Plan Section at Typical Interior Column
(thru Bottom of Precast Log Beams)

SK GF 20120501

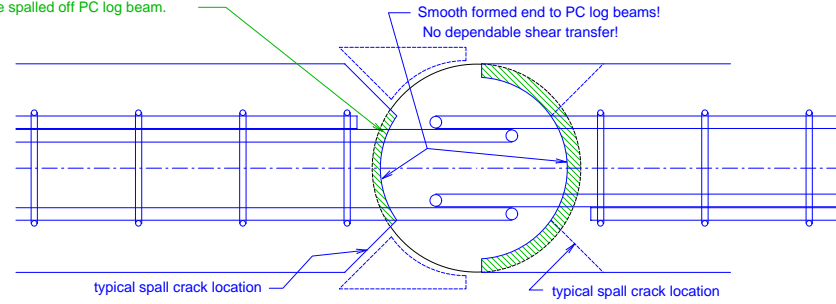
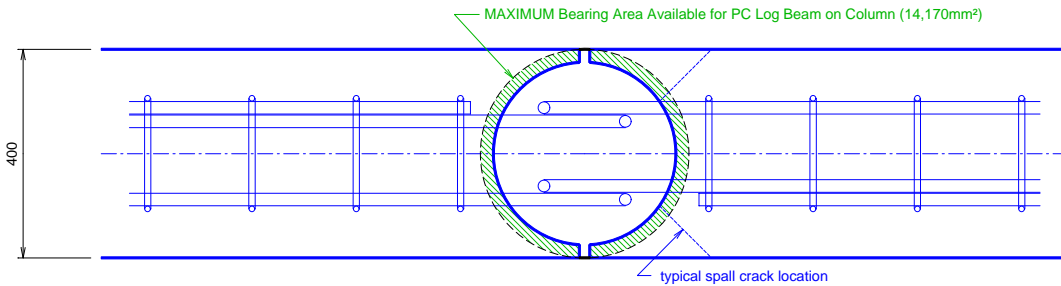
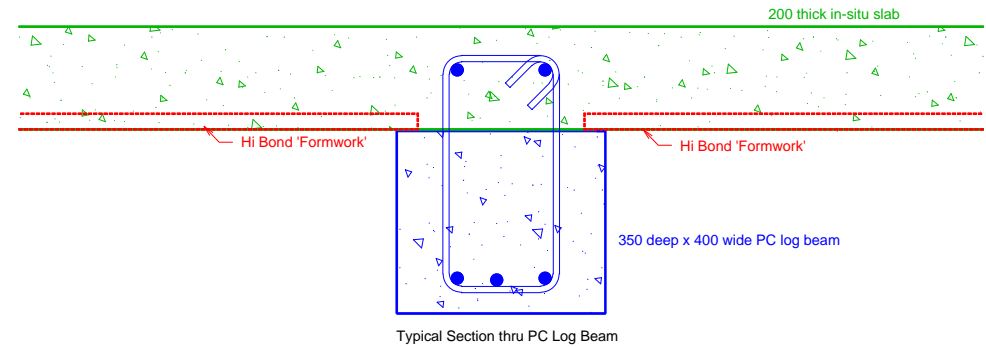
PLAN SECTION 2-2 - INTERIOR BEAM-COLUMN JOINT
(ALLOWING 10mm CONSTRUCTION TOLERANCE)

PLAN SECTION 3-3 - INTERIOR BEAM-COLUMN JOINT
(ALLOWING 10mm CONSTRUCTION TOLERANCE + CORNER SPALLING)

PLAN SECTION 1-1 - INTERIOR BEAM-COLUMN JOINT
(AS DESIGNED)

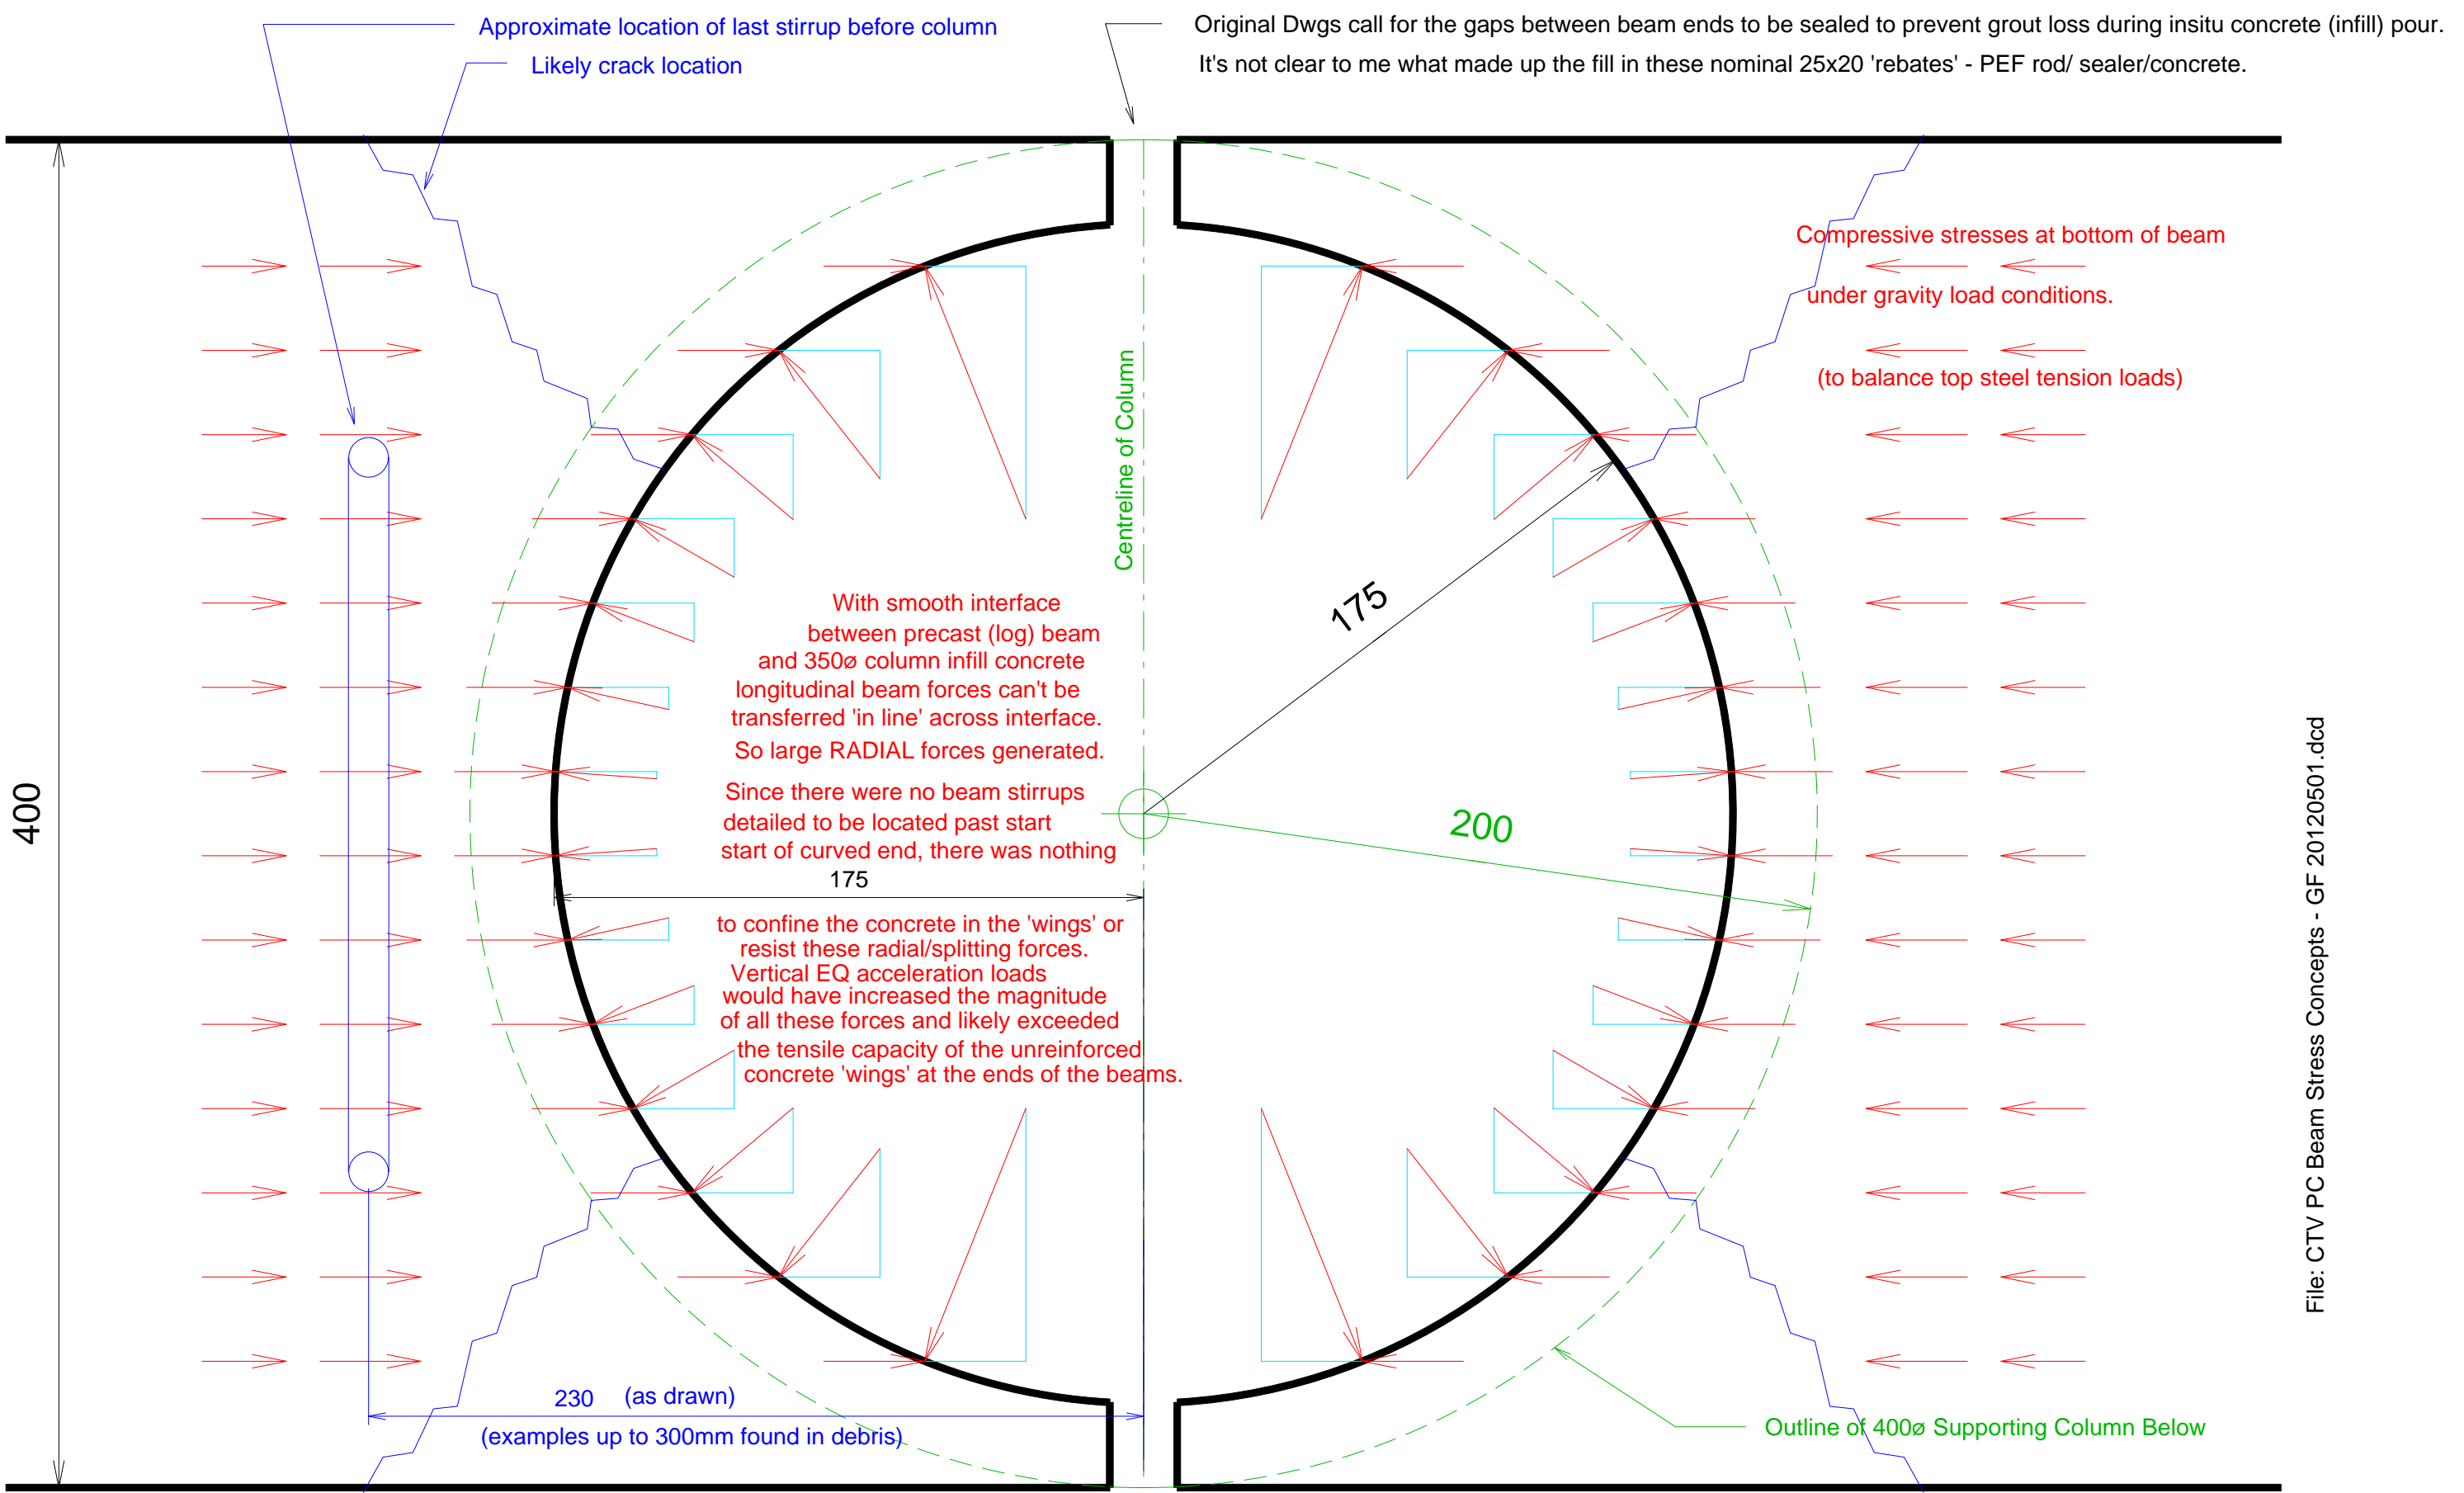
Original Dwgs call for the gaps between beam ends to be sealed to prevent grout loss during insitu concrete (infill) pour. It's not clear to me what made up the fill in these nominal 25x20 'rebates' - PEF rod/ sealer/concrete.

Approximate location of last stirrup before column
Likely crack location

Compressive stresses at bottom of beam
under gravity load conditions.
(to balance top steel tension loads)

With smooth interface between precast (log) beam and 350ø column infill concrete longitudinal beam forces can't be transferred 'in line' across interface. So large RADIAL forces generated. Since there were no beam stirrups detailed to be located past start of curved end, there was nothing

to confine the concrete in the 'wings' or resist these radial/splitting forces. Vertical EQ acceleration loads would have increased the magnitude of all these forces and likely exceeded the tensile capacity of the unreinforced concrete 'wings' at the ends of the beams.

230 (as drawn)
(examples up to 300mm found in debris)

generate large RADIAL forces in at the interface.
